UZBEKISTAN GAS TO LIQUID PROJECT (UZGTL)

HAZOP ACTION CLOSE-OUT REGISTER FOR MAKE-UP H2 COMPRESSOR PACKAGE

UZGTL-HDC-HSE-RP-50-0-0004

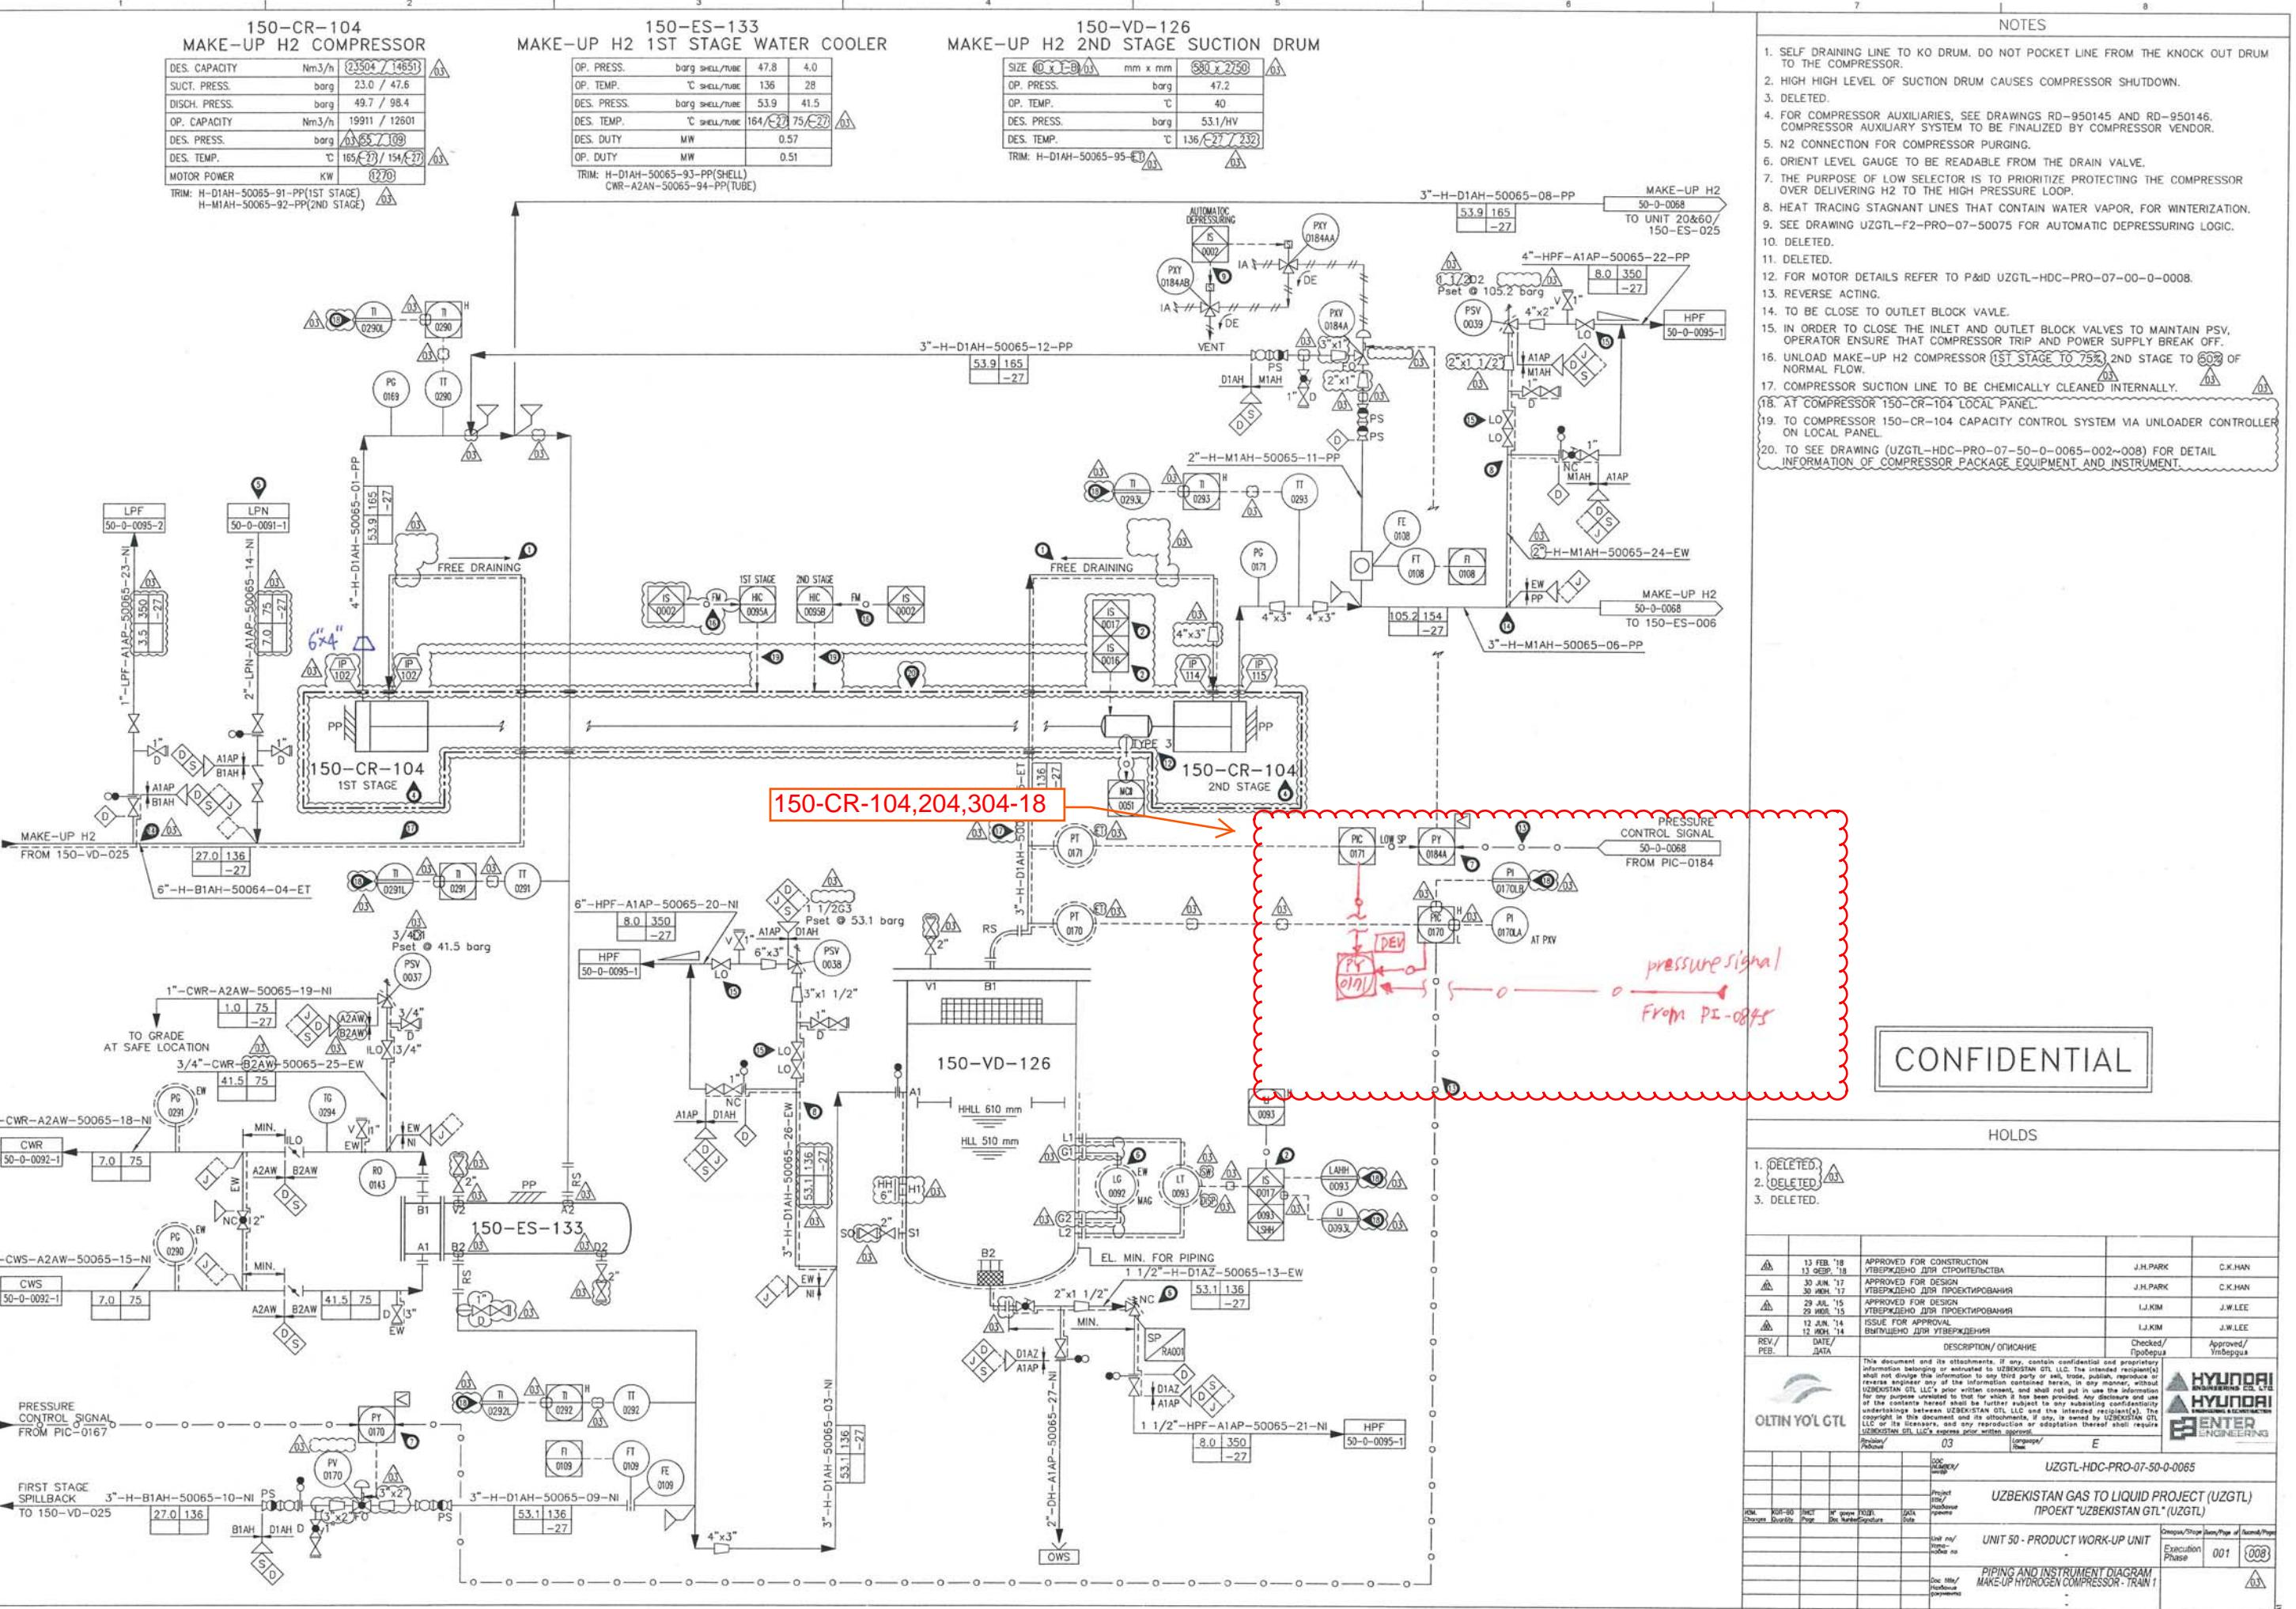
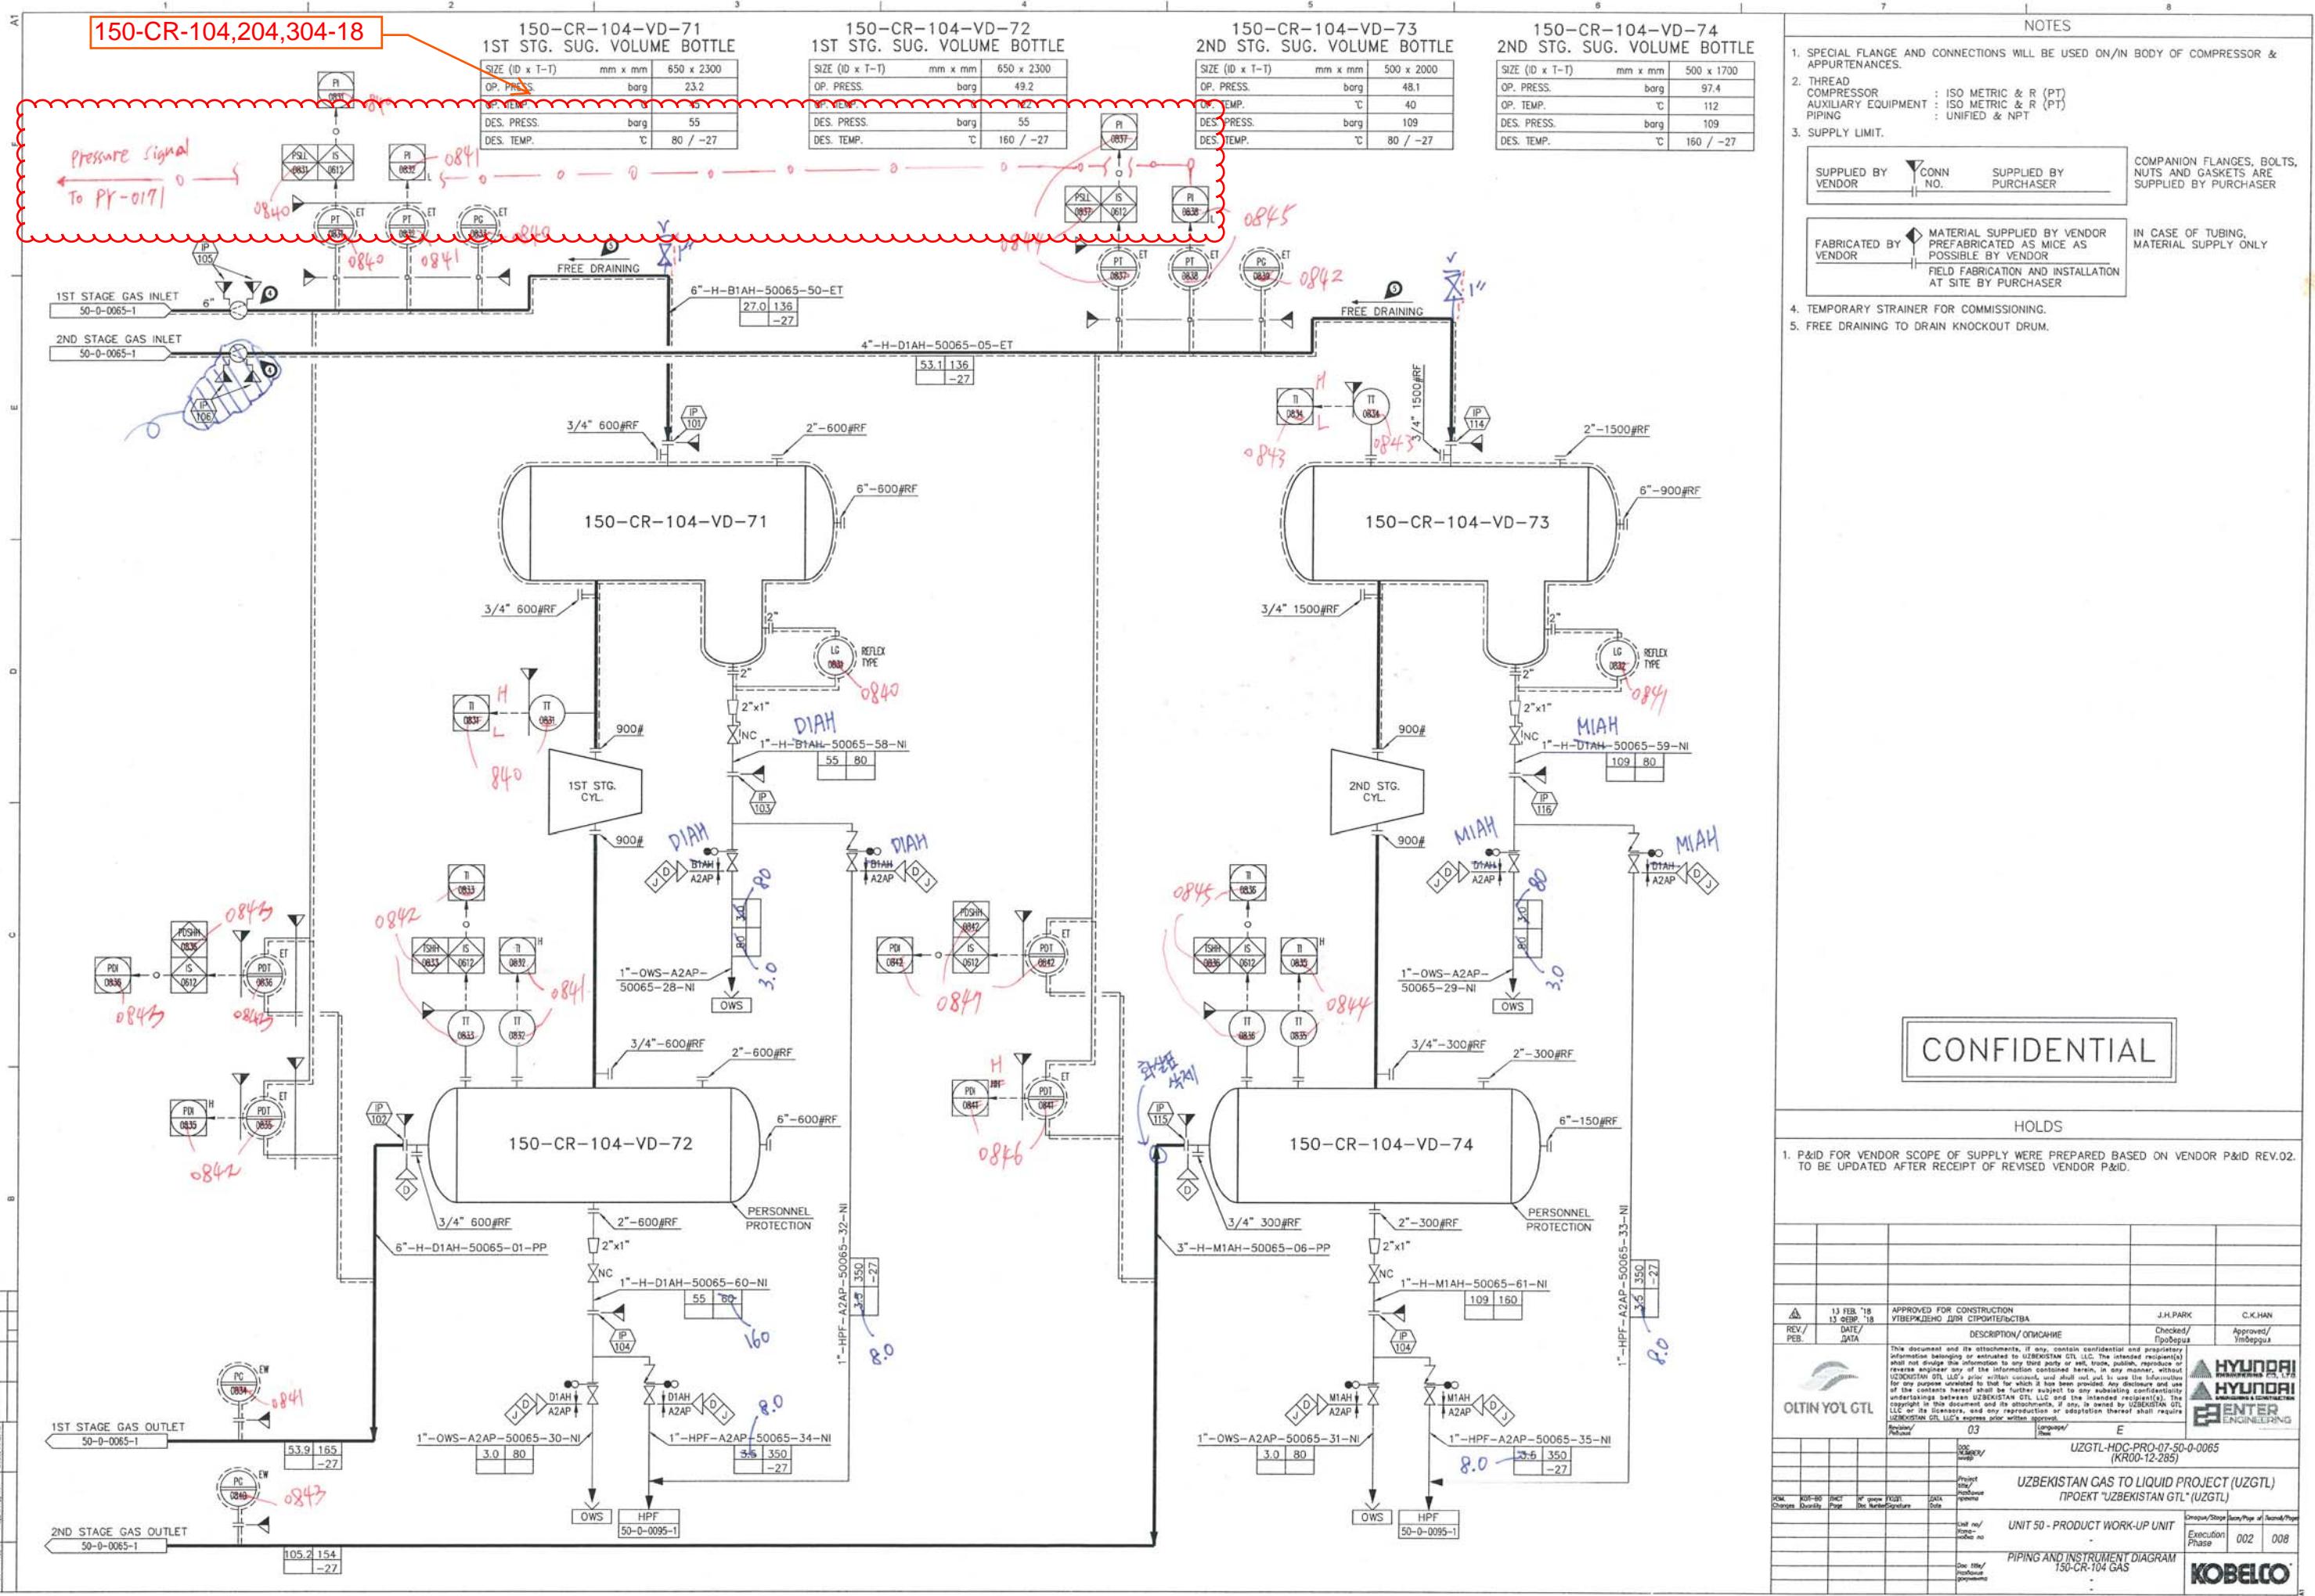
Action No.	150-CR-104/204/304-18	
Action By	PR	
Node No.	1	
Node Description	1. Compressor Process Gas / Compressor Vent & Drain / Compressor Unloader	
Cause	1.2.4. More Flow of process gas via H2 make-up line to Unit 20 / Unit 60 (Refer to Unit 50 Process HAZOP)	
Consequence	1.2.4.2. 2nd stage suction pressure decrease leading to compression ratio increase on 2nd stage resulting in mechanical damage of compressor. Increase of vibration.	
Safeguards	1.2.4.2.1. 150-PAL-0838A 1.2.4.2.2. 150-PSLL-0837A initiates 150-IS-0612 to trip Compressor (SIL rated) 1.2.4.2.3. 150-PDAH-0841A 1.2.4.2.4. 150-PDSHH-0842A initiates 150-IS-0612 to trip Compressor 1.2.4.2.5. 150-VAH-0831A (MMS) 1.2.4.2.6. 150-VSHH-0832A initiates MMS interlock to trip Compressor	
Action	Configure deviation alarm on DCS between 150-PT-0170, 150-PT-0171 and 150-PT-0838A

Response	Incorporated on P&ID (50-0-0065/66/67-1/2). Deviation alarm on DCS between 150-PT-0170, 150-PT-0171 and 150-PT-0838A will be provided. (Please refer to attached P&ID, UZGTL-HDC-PRO-07-50-0-0065/66/67-1/2)
